NEW SYSTEM VARIANCE REQUEST

Property Owner's Name: ROLAND LACROIX
System's Location: RTE 105
Property Owner's Address: 1/6 FRED PATRICK 297 CONY ST EXT
(if different from above) AUGUSTA, MA 04330

SUBSURFACE WASTEWATER DISPOSAL SYSTEM APPLICATION

NEW SYSTEM VARIANCE REQUEST APPROVAL

DESIGN DETAILS (SYSTEM LAYOUT SHOWN ON PAGE 3)

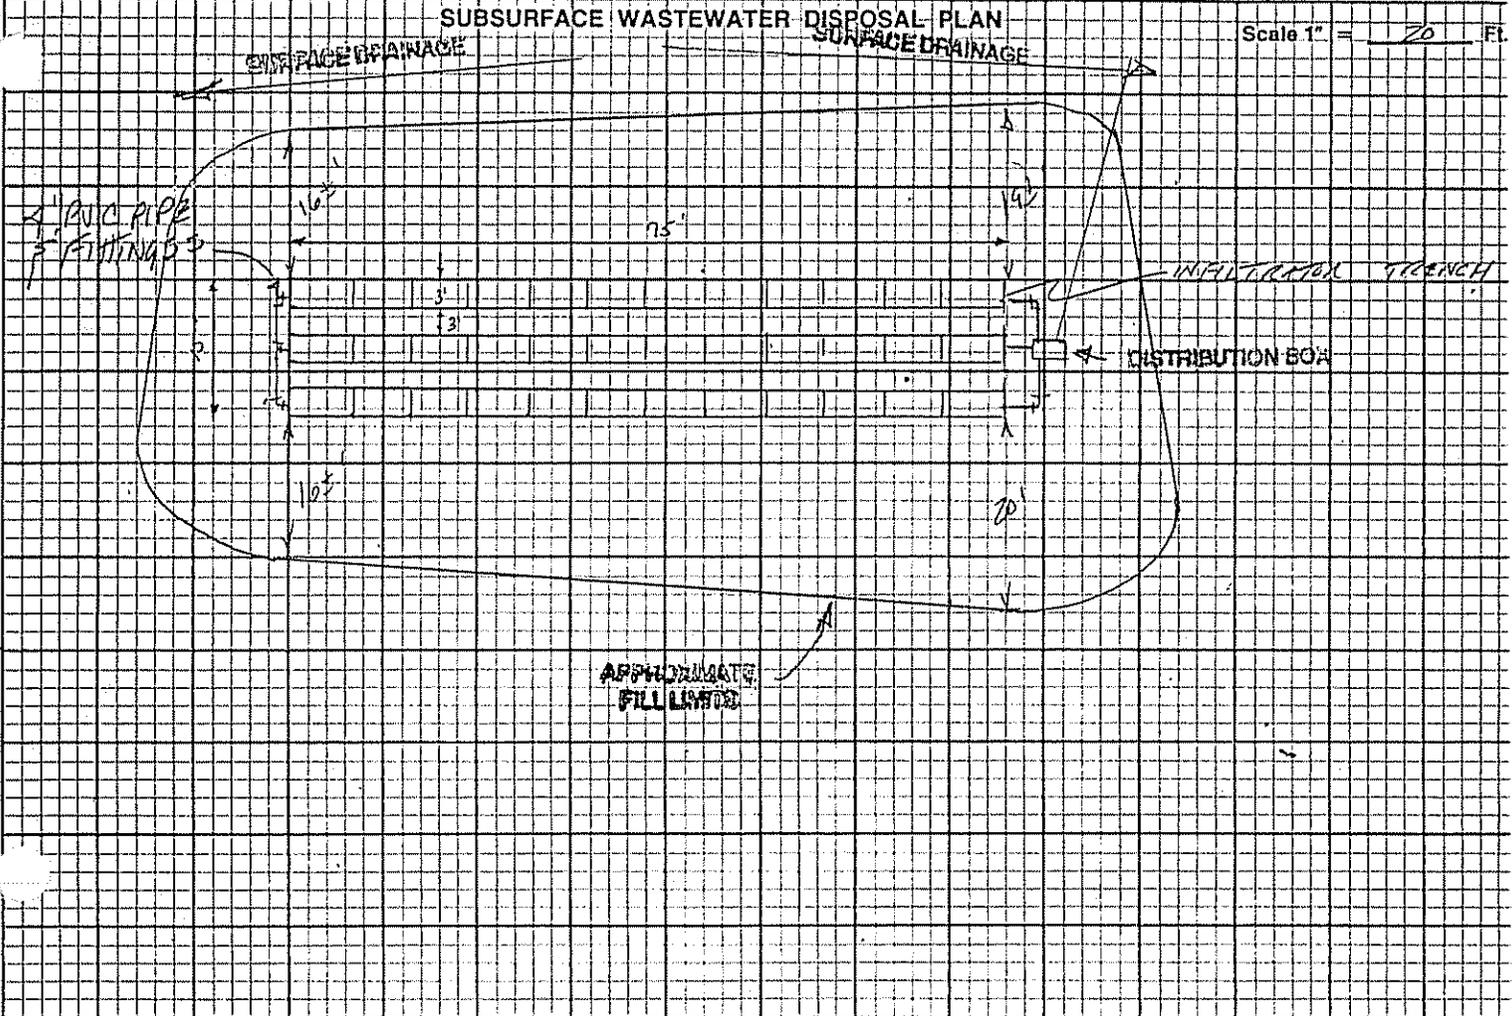
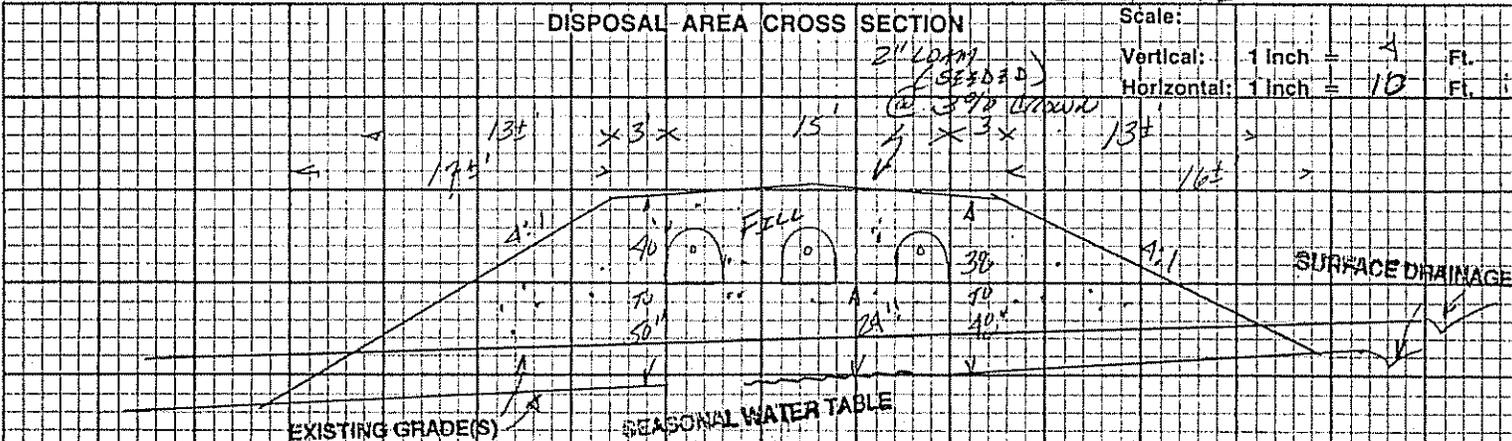
1. LESS THAN 15" TO SEASONAL WATER TABLE 6B3a
2. _____
3. _____

CHARACTERISTIC	POINT ASSESSMENT
Soil Profile	<u>B</u>	<u>10</u>
Depth to Groundwater	<u>10"</u>	<u>3</u>
Size of Property	<u>4 ACRES</u>	<u>8</u>
Terrain	<u>KNOLL</u>	<u>5</u>
Waterbody Setback	<u>300' ±</u>	<u>3</u>
Water Supply	<u>DRIILLED</u>	<u>3</u>
Type of Development	<u>SINGLE FAMILY</u>	<u>0</u>
Design Flow	<u>MIN + 16%</u>	<u>10</u>
Separation Distance	<u>MIN + 100%</u>	<u>10</u>
Additional Treatment	<u>—</u>	<u>—</u>
TOTAL POINT ASSESSMENT		<u>52</u>

CONCLUSIONS: I, Mary R. Tully, the undersigned, have visited the above property and find that it is not possible to conform to certain provisions of the Rules. The variance request submitted by the applicant is the best alternative for a subsurface wastewater disposal system on this property.

This approval requires that:

1. The system is installed in compliance with the submitted and approved Site Evaluator's design dated 6/26/88 - 6/6/92,
2. The Site Evaluator, who designed the system, is retained to establish the exact location and elevation of the system at the time of construction,
3. A permit is obtained from the Local Plumbing Inspector prior to installing the system,
4. The well location meets all setback distance requirements.
